The Commission has issued the enclosed Amendment No. 92 to Facility Operating License No. DPR-23 for the H. B. Robinson Steam Electric Plant Unit No. 2. This amendment consists of changes to the Technical Specifications in response to your request dated December 10, 1984.

H. B. ROBINSON STEAM ELECTRIC PLANT, UNIT NO. 2

Amendment No. 92
License No. DPR-23

SAFETY EVALUATION BY THE OFFICE OF NUCLEAR REACTOR REGULATION
RELATED TO AMENDMENT NO. 92 TO FACILITY OPERATING LICENSE NO. DPR-23
CAROLINA POWER AND LIGHT COMPANY
H. B. ROBINSON STEAM ELECTRIC PLANT, UNIT NO. 2
DOCKET NO. 50-261

H.B. ROBINSON UNIT #2
 Carolina Power & Light Company
 FINAL SAFETY ANALYSIS REPORT
 FACILITY ORGANIZATION
 ROBINSON NUCLEAR PROJECT
 Figure 6.2-2

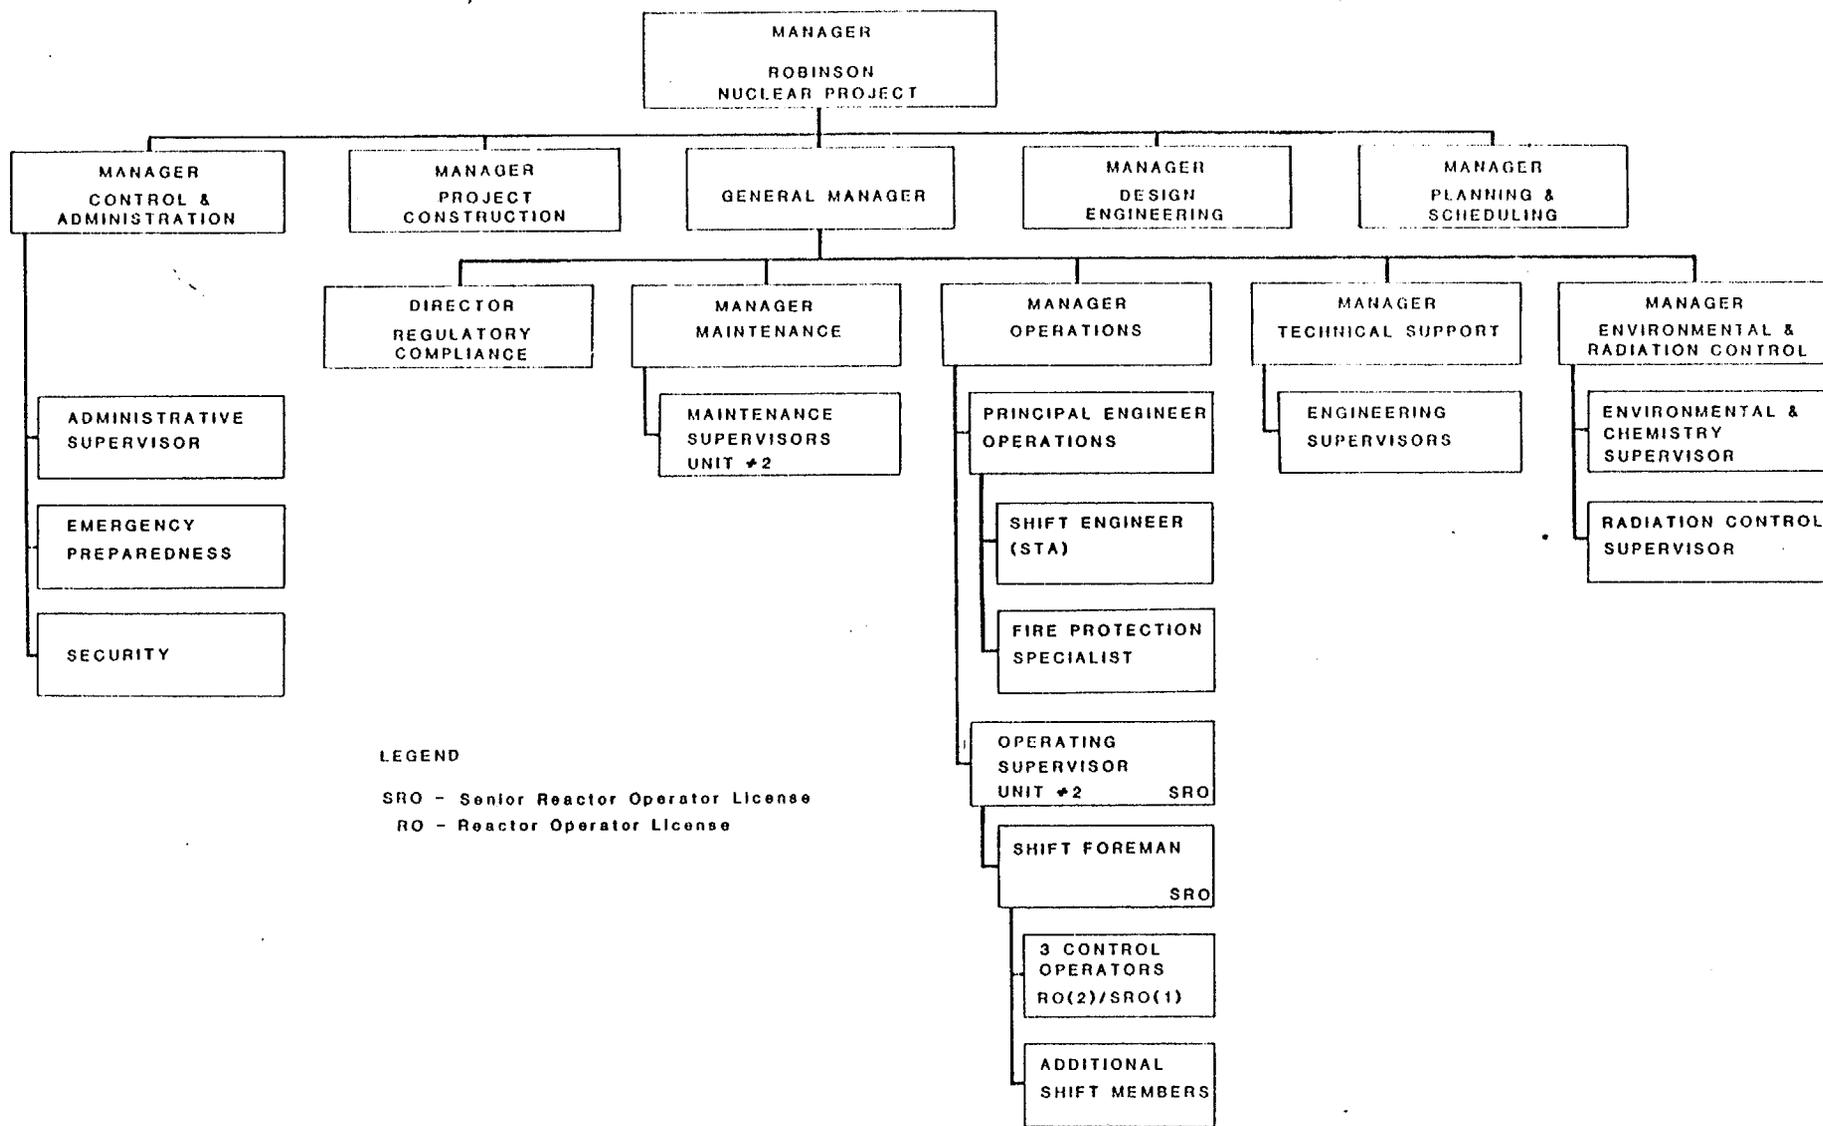
In their letter dated December 10, 1984, Carolina Power and Light Company (the licensee) proposed changes to the Administrative Controls requirements, Section 6, of the Technical Specifications. The licensee's request for the proposed change was based on an organizational change that replaced the Manager of Operations and Maintenance (a dual position) and adding a manager to provide two singular positions; Manager Operations and Manager Maintenance. Figure 6.2-2 and Specification 6.4.2 and 6.5.1.6.2 have been revised to reflect the two new positions.

In support of their requested change, the licensee states that by splitting the previous dual position of Manager-Operations and Maintenance into the two positions of Manager Operations and Manager Maintenance would allow more dedicated management over both the operation and maintenance functions.

The staff has reviewed the proposed change and finds that "unloading" multiple duties of a manager and dividing the work load between several managers can allow more dedicated management to each duty, therefore, the change could have a positive safety impact. Based on the above discussion the staff finds the proposed change acceptable.
